15 November 2013

**STATE SIGNIFICANT DEVELOPMENT NO.5251 - DUBBO ZIRCONIA PROJECT (DZP), TOONGI, DUBBO LOCAL GOVERNMENT AREA**

Figure 1: Detail from the Open Space Master Plan adopted by Council 23 March 2009, Volume 2. Map 7: Connectivity Projects (excerpt). The dashed line marked No.2 is defined as a shared pathway along the railway corridor.

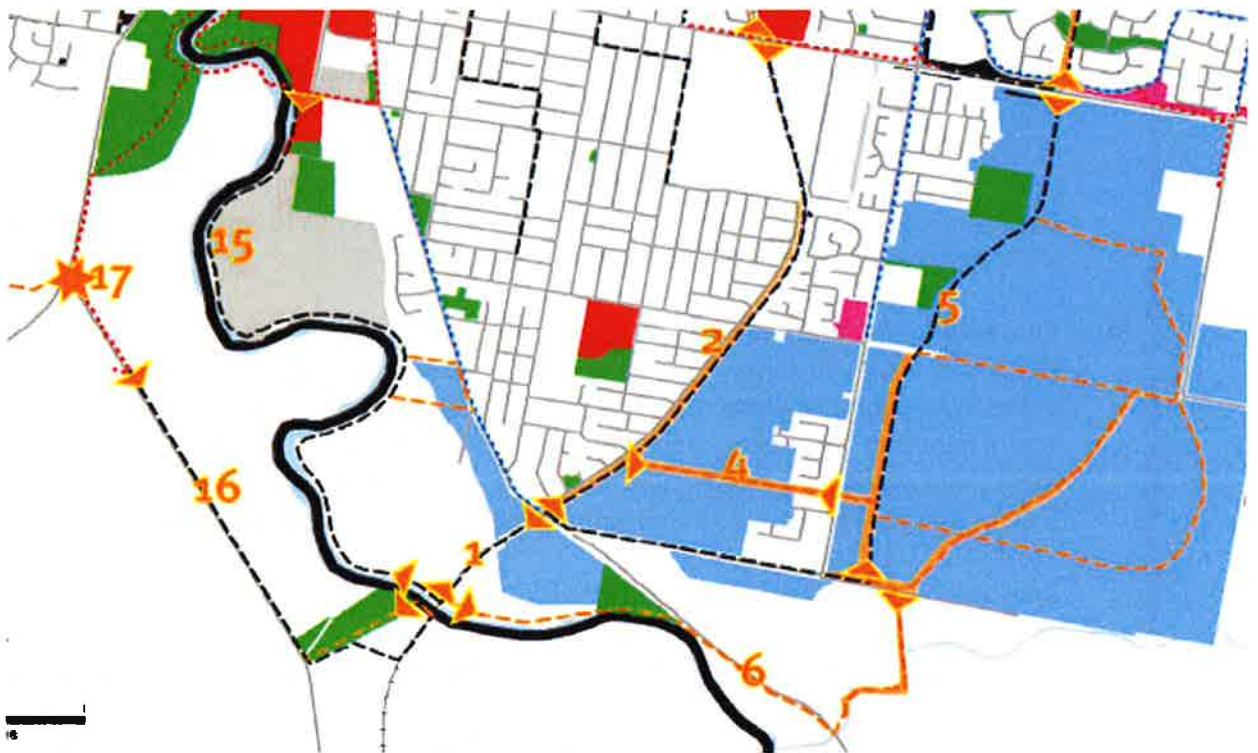
Where the dashed line marked 'no. 4' intersects with the dashed line marked '2', Council requires provision of a pedestrian/bicycle crossing. This will allow integration of all pathways within the network and reduce the motivation by the public to damage a fence and access/cross the railway at a number of informal points.

Figure 3: The line marked '3' is defined as a shared pathway link between the shared pathways that run along both Cobra Street and Birch Avenue (Open Space Master Plan Vol 2, Map 7).

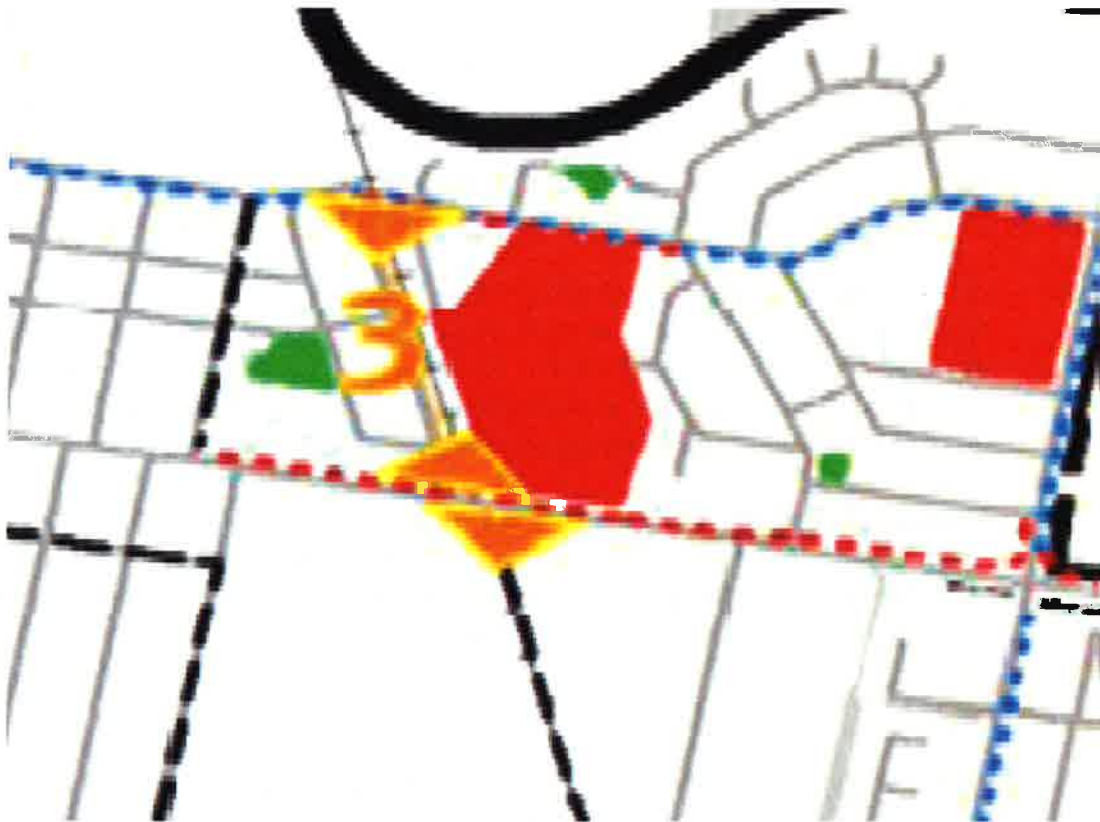
- (g) In the block between Cobra Street and Birch Avenue, there are similar issues with trees and shared pathway crossings. The minimising of enclosure to the west of the rail line should

continue from Margaret Crescent up to and including this block. This will minimise tree loss and will allow the installation of a shared pathway along the Chelmsford Avenue side of the railway corridor (see Figure 3 below). The railway crossings will have to be fenced appropriately as other existing crossings are in the urban area. Apex Oval East Dubbo football complex is a major node in the Open Space network.
